FLORIDA POWER & LIGHT COMPANY

ST. LUCIE PLANT UNIT NO. 1

Amendment No. 28
License No. DPR-67

ATTACHMENT TO LICENSE AMENDMENT NO. 28

FIGURE 3.4-2a

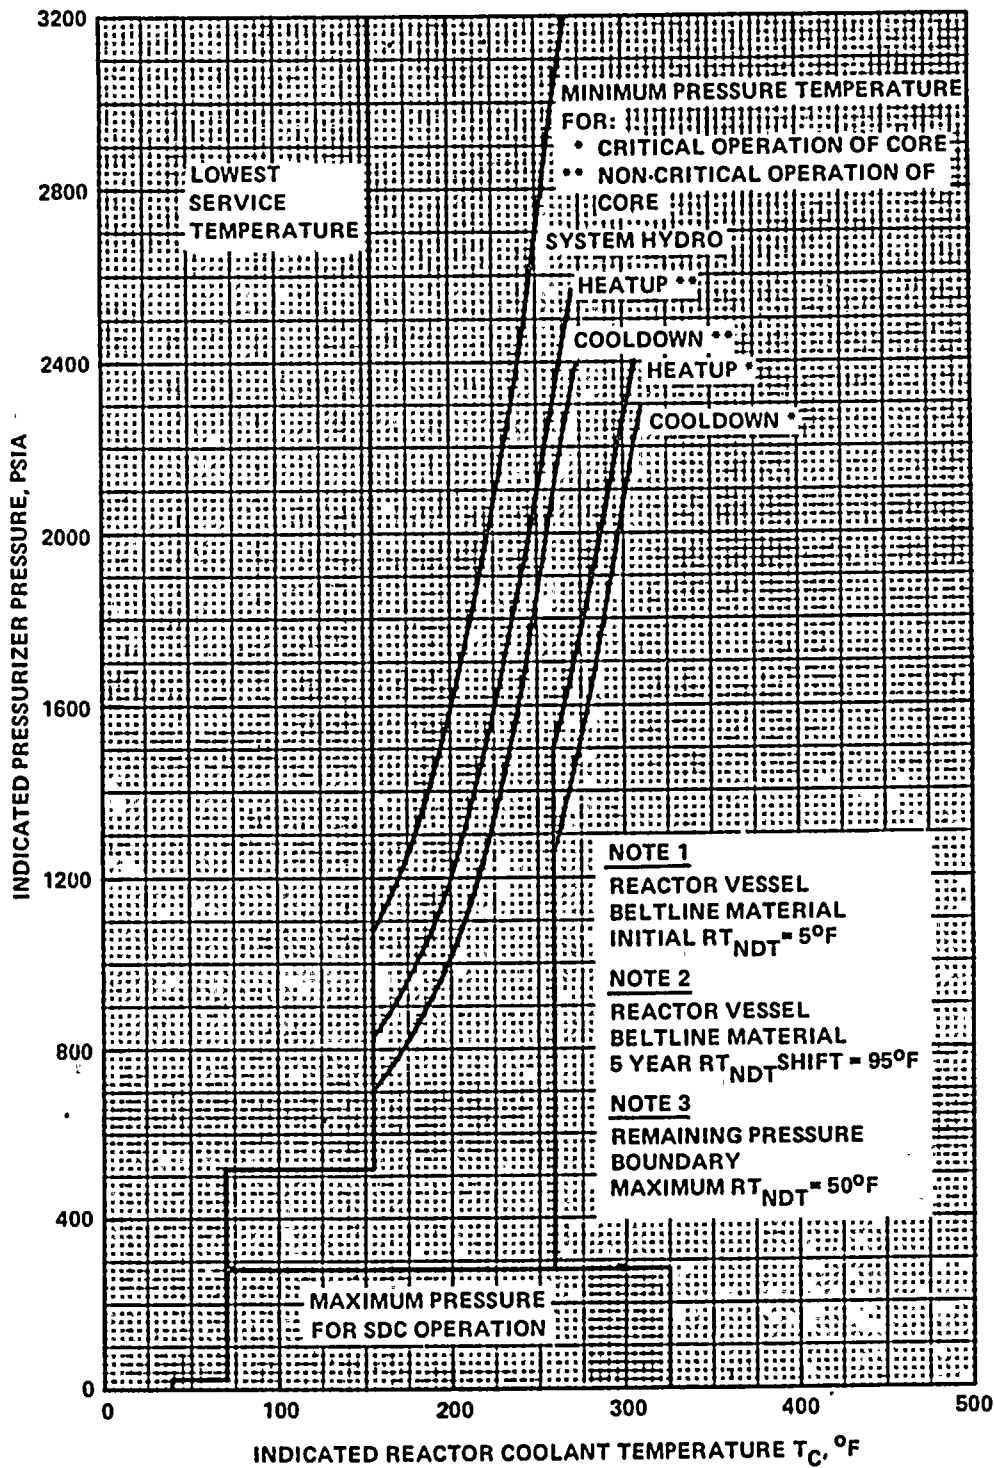
Reactor Coolant System Pressure Temperature Limitations
for up to 5 Years of Full Power Operation

FIGURE 3.4-2b

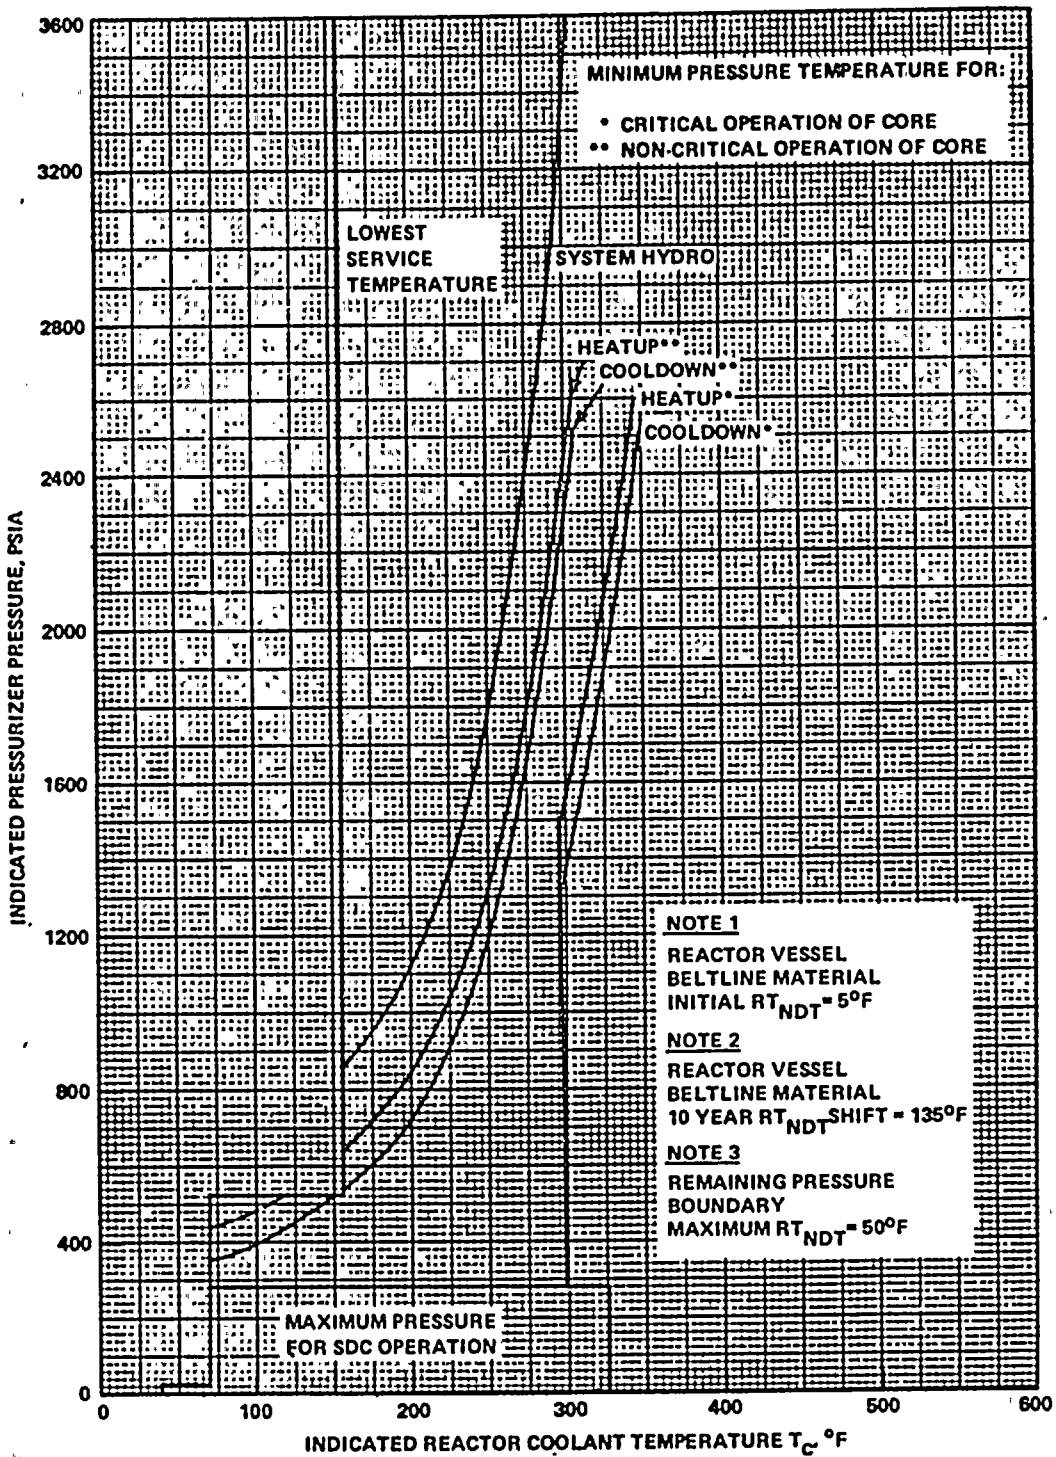
Reactor Coolant System Pressure Temperature Limitations
for up to 10 Years of Full Power Operation

FIGURE 3.4-2c

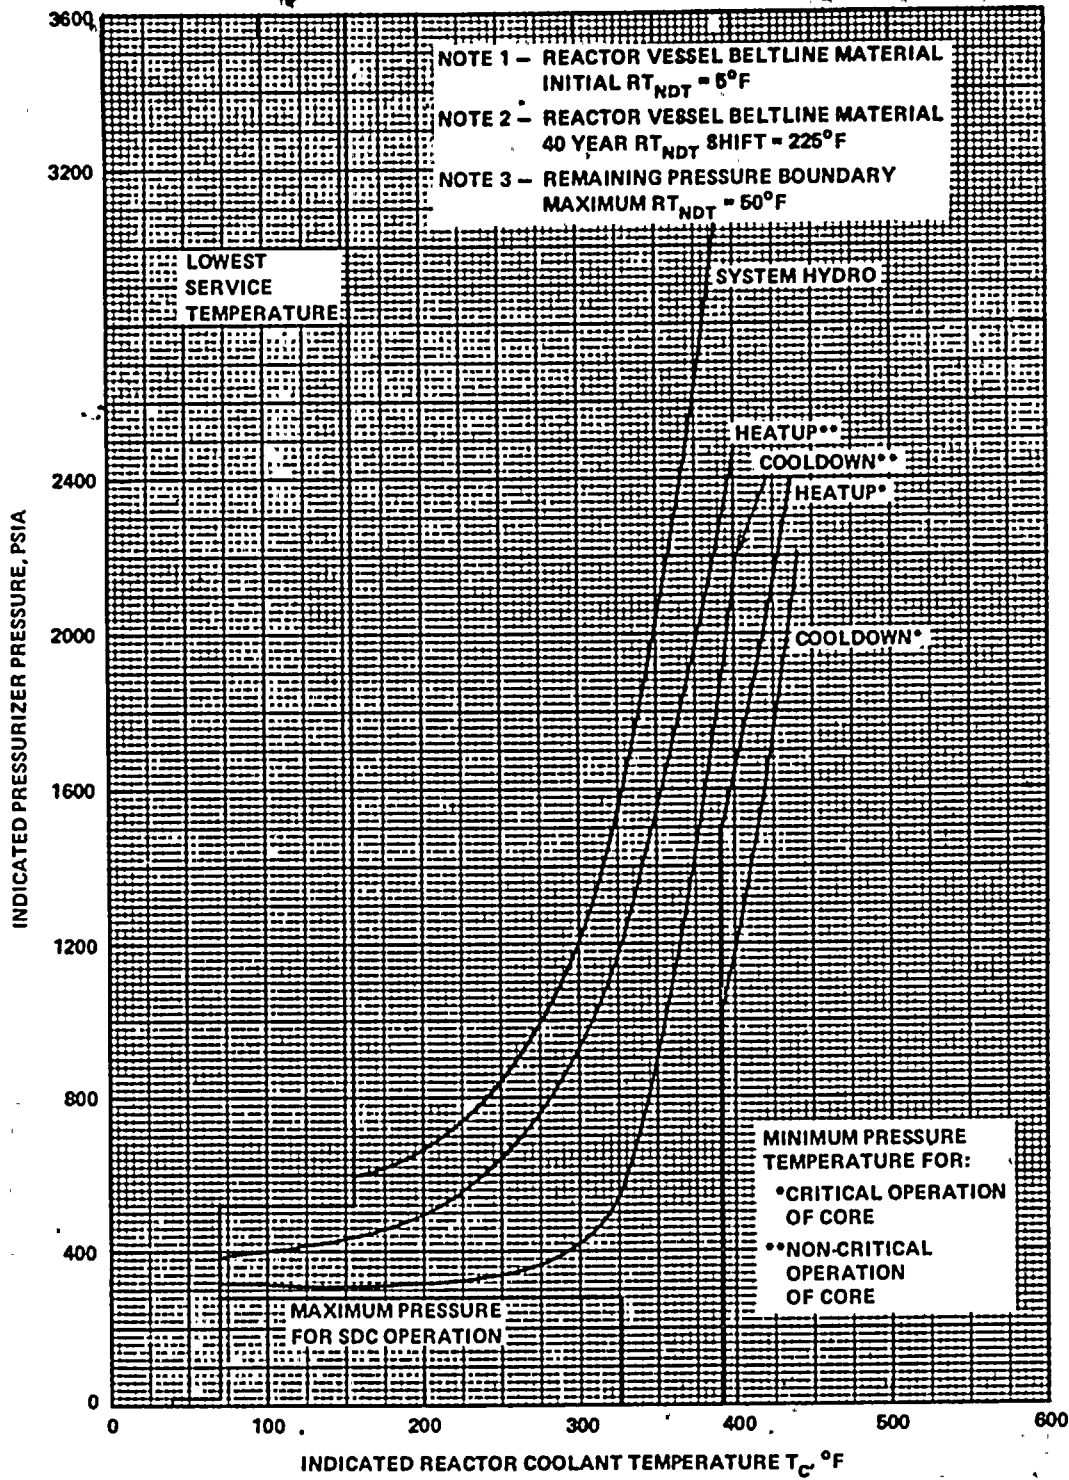
Reactor Coolant System Pressure Temperature Limitations
for up to 40 Years of Full Power Operation
